- Subject** ▶ Change of Handle Spring and Handle Base
- For Models** ▶ HM1100C, HM1100, HM1200B, HM1211B, HM1200, HM1200K, ( Demolition Hammer )
- Note** ▶ This information applies to all countries except for HM1200.  
For HM1200 this information applies to France, Reunion, Algeria, the Netherlands , Germany, Spain, Italy, Austria, Norway, Sweden, Finland and Switzerland.
- Description** ▶ As illustrated below, the shape of Handle Spring and Handle Base have been changed, for improvement in endurance.

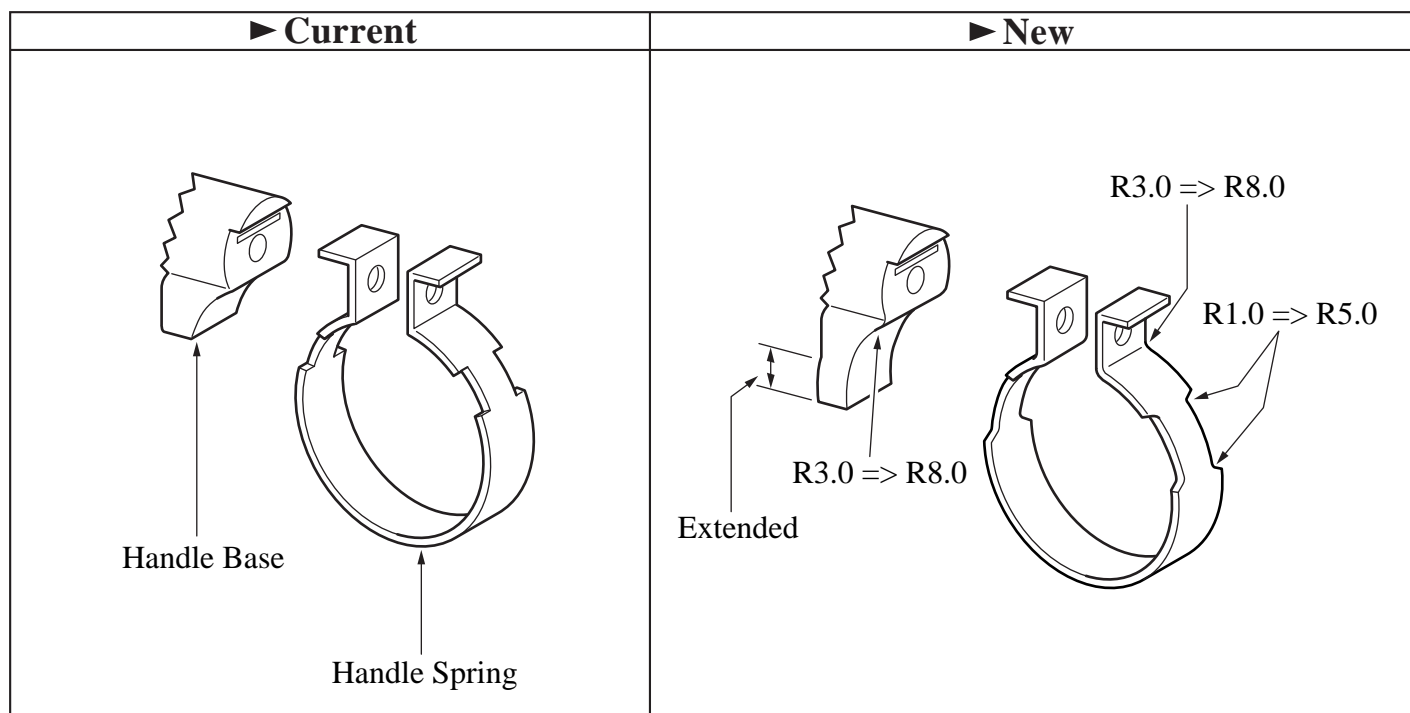
Item No.	Current part		Q'ty	I/C	New part		Q'ty	Note
71	Handle Spring 60 344379-2		1	No	Handle Spring 60 344559-0		1	For all the Models listed above except for HM1200K Interchangeable as a set
70	Handle Base 60 416010-1		2	No	Handle Base 60 416396-3		2	
99	Handle Spring 48 344378-4		1	No	Handle Spring 48 344560-5		1	For Modle HM1200K Interchangeable as a set
45	Handle Base 48 416008-8		2	No	Handle Base 48 416397-1		2

HM1100C : From serial No.7087  
HM1100 : From serial No.3072  
HM1200B : From serial No.7319

HM1211B : From serial No.6442  
HM1200 : From serial No.39128  
HM1200K : From serial No.45278
